**NSLPP MEETING HELD ON 07/05/2025**

**ADDRESS/WARD:** 111-115 Chandos Street, Crows Nest

**APPLICATION No:** DA363/24

**PROPOSAL:** Demolition of existing building and construction of a 5-storey residential flat building with rooftop terrace

**Figure 6: Height Plane Diagram**

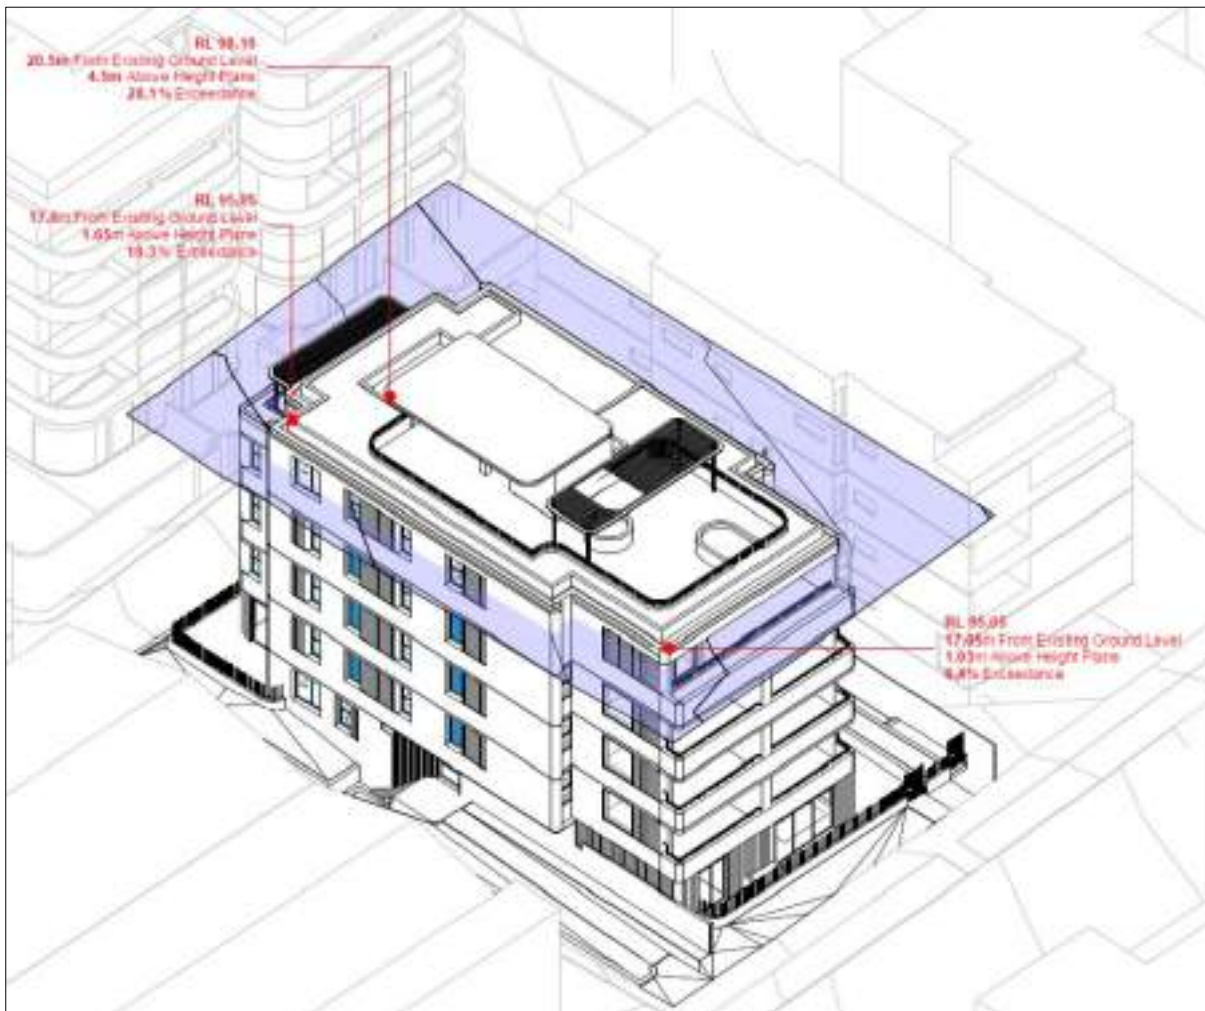
Approximately 50% of proposed Level 4 sits above the permitted height plane which is not acceptable. The Roof Level contributes to further height exceedance via the lift overrun and stairs lobby, and the proposed pergola structure. The height exceedance is not sympathetic with surrounding development on the southern side of Chandos Street and is unacceptable.

1 EAST ELEVATION - HUME LANE  
SCALE 1:100

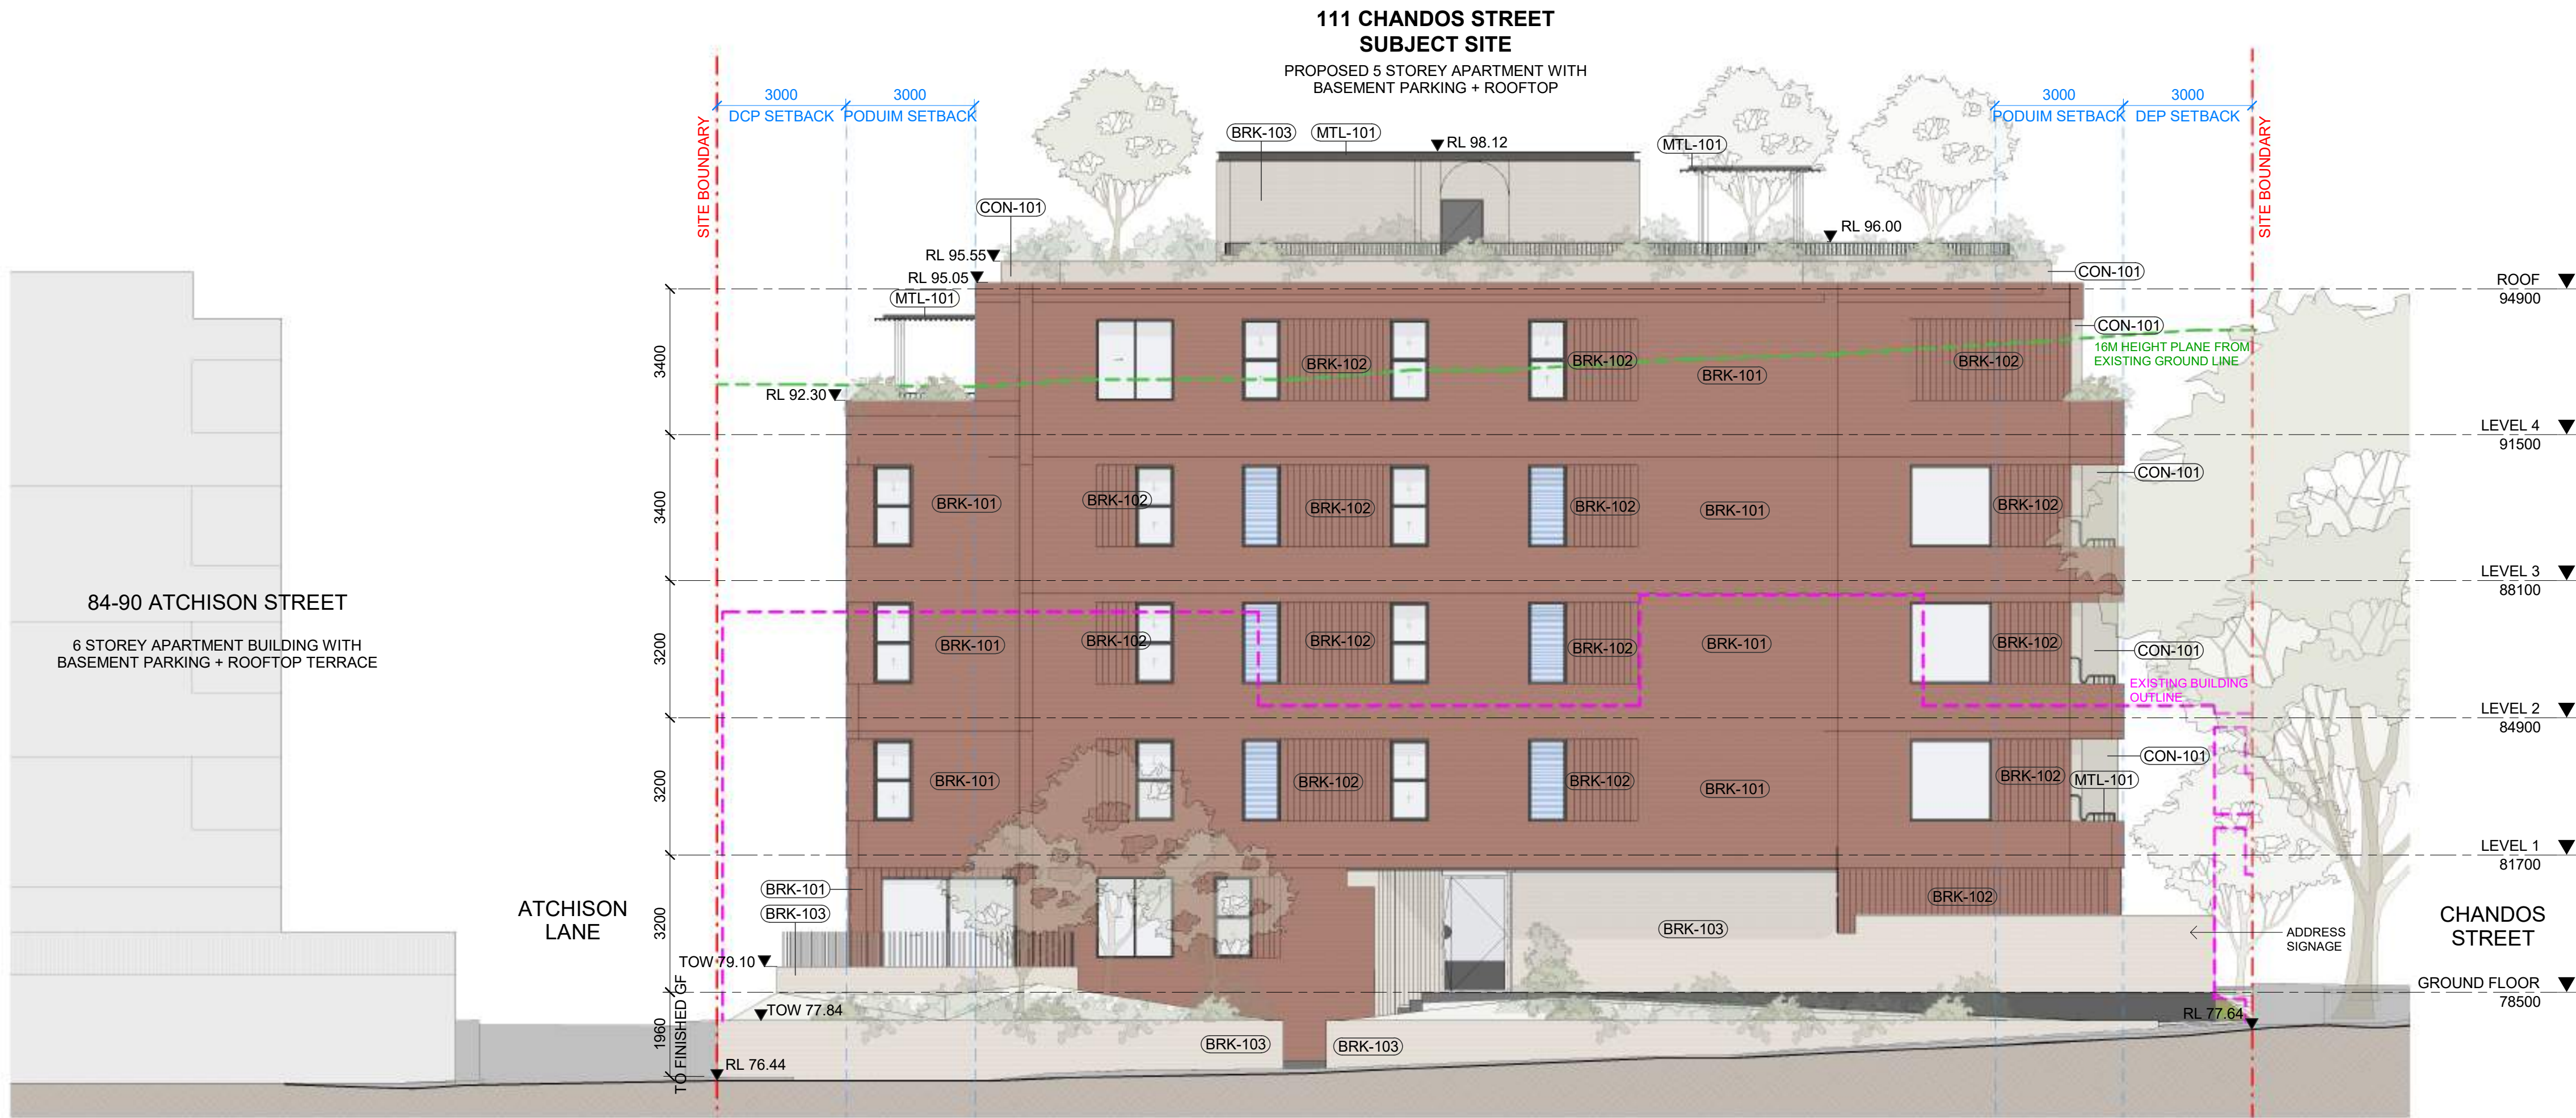
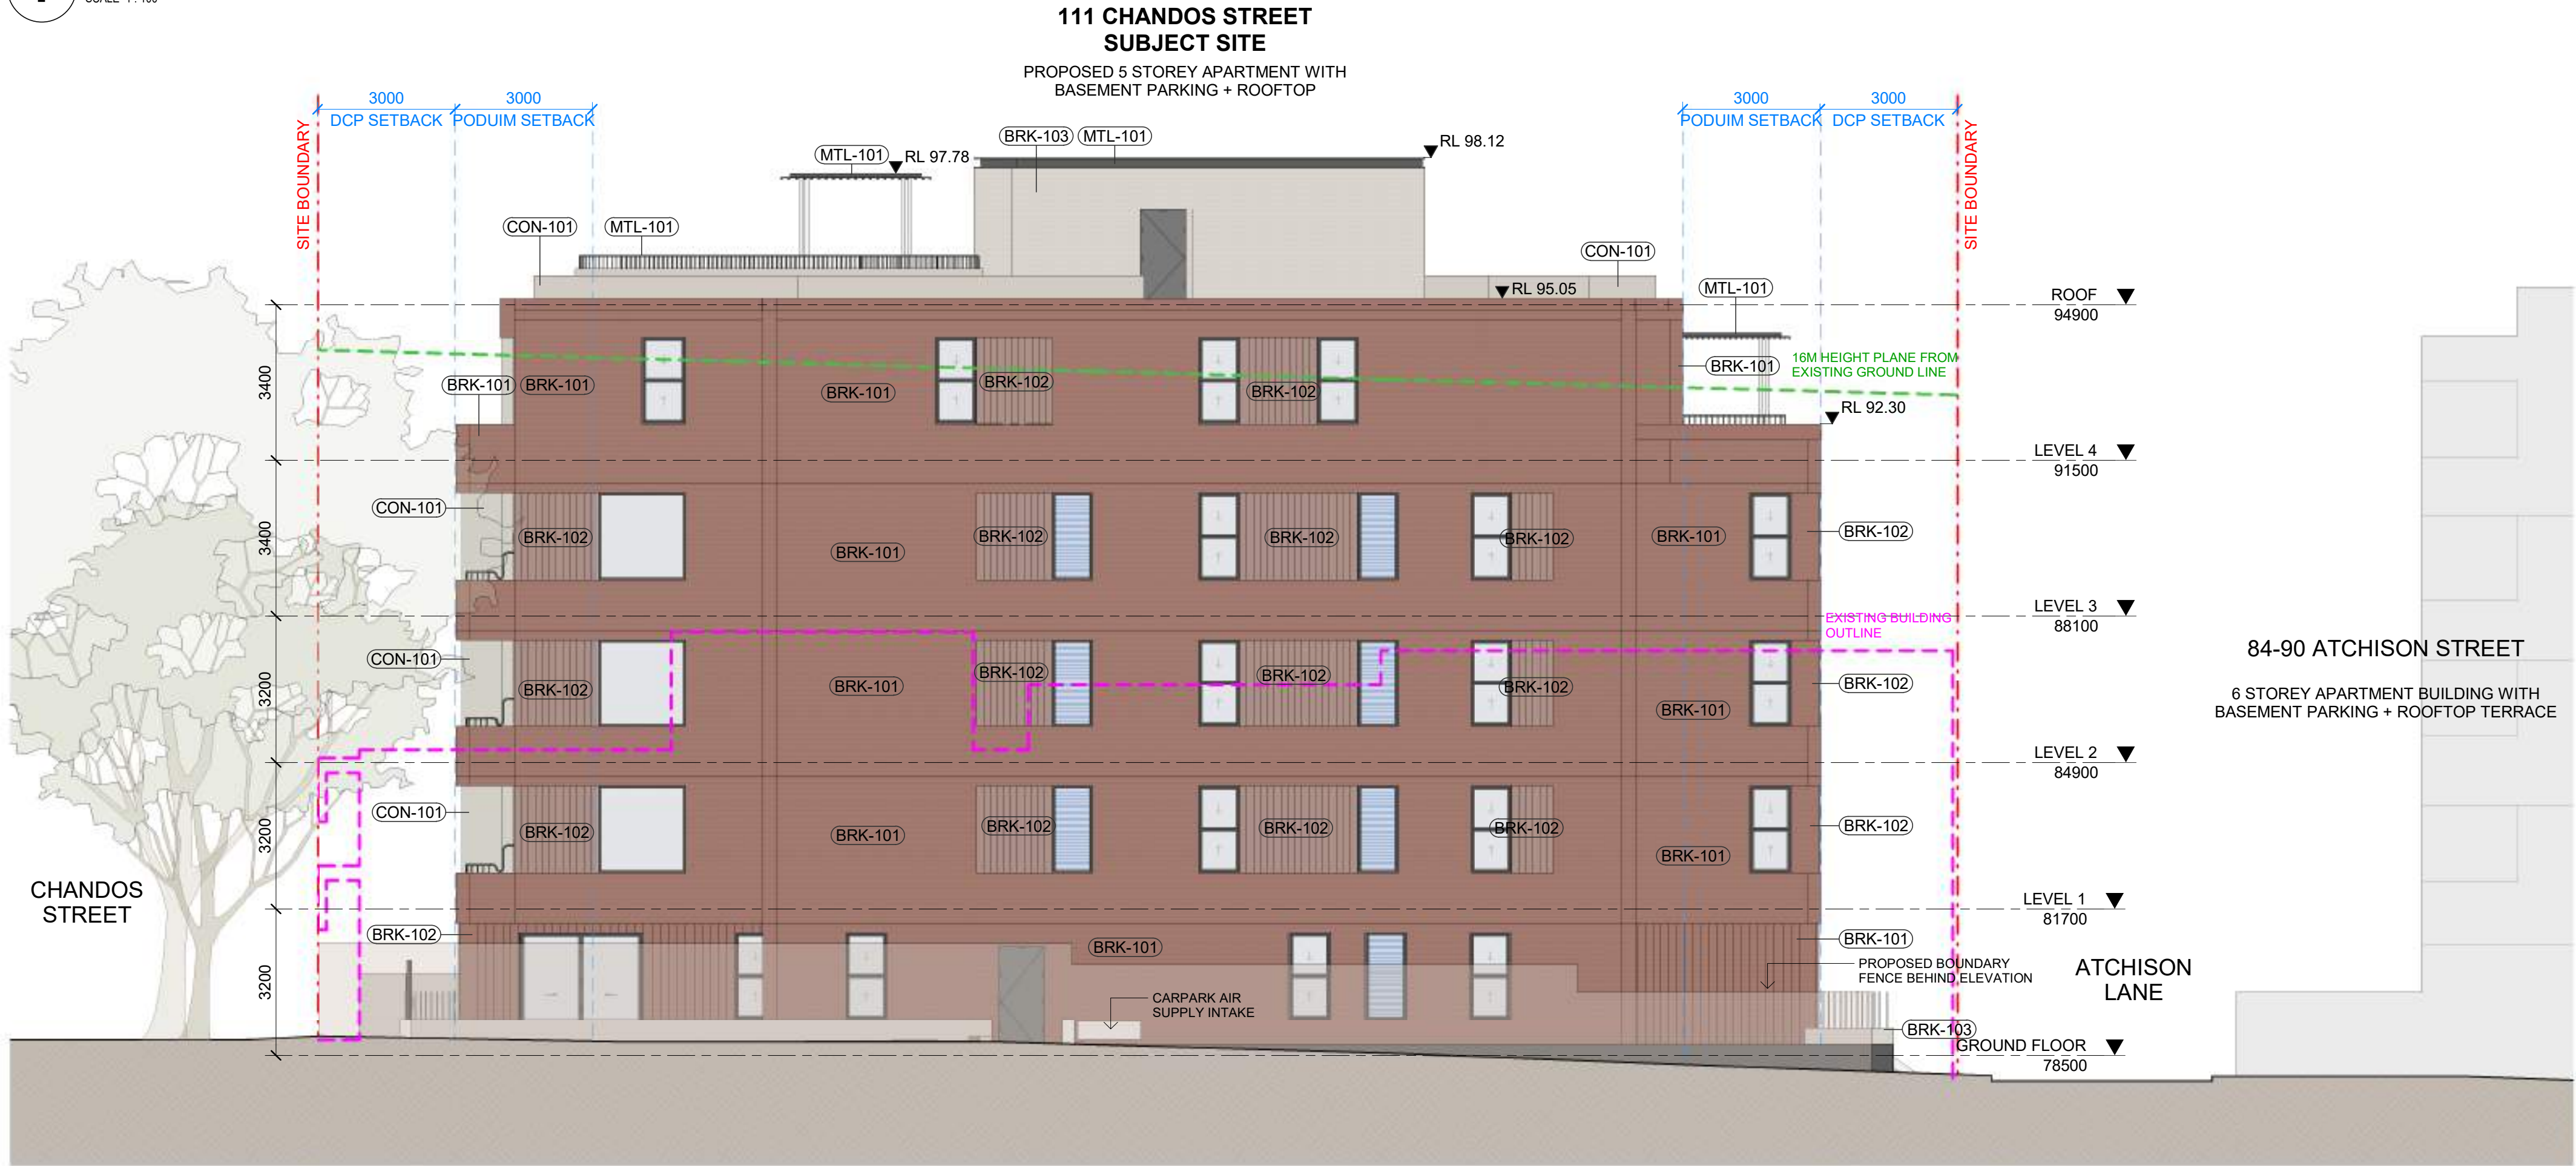
- (c) An outline of the eastern elevation window openings of 107-109 Chandos Street on the western elevation drawing of the proposal, to assess the extent of visual privacy impacts.

The proposed development does not provide adequate articulation. The proposed eastern elevation partially consists of a 19.1m unmodulated wall over four stories, which should be articulated to reduce the bulk and massing of the development.
